Access Compliance Report

Public Rights-of-Way

(Curb Ramps)

Intersection ID: 5741	Main Street: MALLARD_CREEK_RD	Cross Street: NEVIN_RD	Location:	N
ADA ID: B6D24518FE44	Ramp Type: Perp	Initial Pass/Fail: Fail	Overall Compliance: No	Severity Score: 8.75
Codes/Mitigation Info/Possible Solution		Field Measurements/Component Compliance

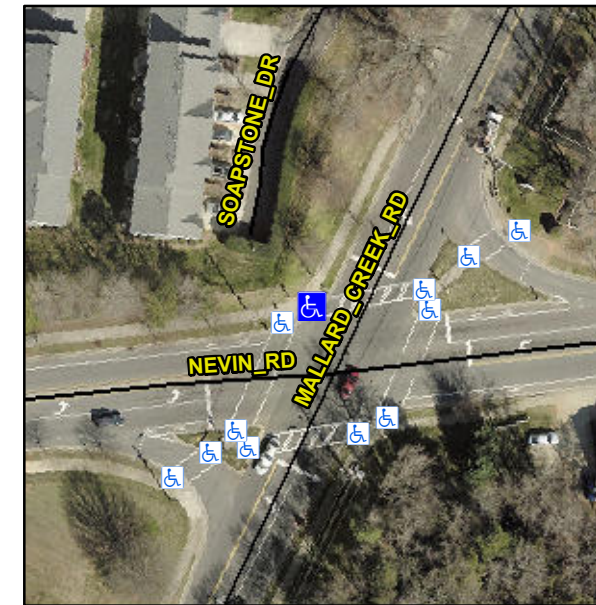
Not Found, R304.5.1

Compliance	Description	Data	Compliance	Description	Data
N/A	Ramp Length (in)	60.0	Yes	Ramp Slope (%)	5.2
No	Ramp Width (in)	46.5	Yes	Ramp XSlope (%)	0.4
N/A	Flare Type LT	N/A	N/A	Flare Type RT	N/A
N/A	Flare Slope LT (%)	N/A	N/A	Flare Slope RT (%)	N/A
N/A	Flare Traversable LT?	N/A	N/A	Flare Traversable RT?	N/A
N/A	Landing Length (in)	N/A	N/A	DWS Provided?	N/A
N/A	Landing Width (in)	N/A	N/A	DWS Contrast?	N/A
N/A	Landing Slope (%)	N/A	N/A	DWS Length (in)	N/A
N/A	Landing X Slope (%)	N/A	N/A	DWS Full Width?	N/A
N/A	Landing Curb? (Y/N)	N/A	N/A	DWS Offset (in)	N/A
N/A	Shared Landing?	N/A			
N/A	Gutter Ponding?	N/A	N/A	Gutter Slope (%)	N/A
N/A	Gutter Lip Ht (in)	N/A	N/A	Gutter X Slope (%)	N/A
N/A	Painted X Walk1?	Yes	N/A	Painted X Walk2?	N/A
	X Walk 1 Direction	To E		X Walk 2 Direction	N/A
N/A	X Walk 1 Width (in)	121.0	N/A	X Walk 2 Width (in)	N/A
	X Walk 1 Slope (%)	2.8		X Walk 2 Slope (%)	N/A
	X Walk 1 X Slope (%)	2.8		X Walk 2 X Slope (%)	N/A

N/A	Ramp inside XWalk1?	Yes	N/A	Ramp inside XWalk2?	N/A
	Road Slope (%)	N/A	N/A	Clear Space?	N/A
	Road X Slope (%)	N/A	N/A	Clear Space to XWalk (in)	N/A
N/A	Any Obstructions?	N/A	N/A	Storm Grate/Utility Hazard?	N/A
	Obstruction Type			Storm Grate/Utility Type	
		N/A			N/A
			Yes	Surface Condition? (G/P)	Good

Remove & Replace Entire Ramp.
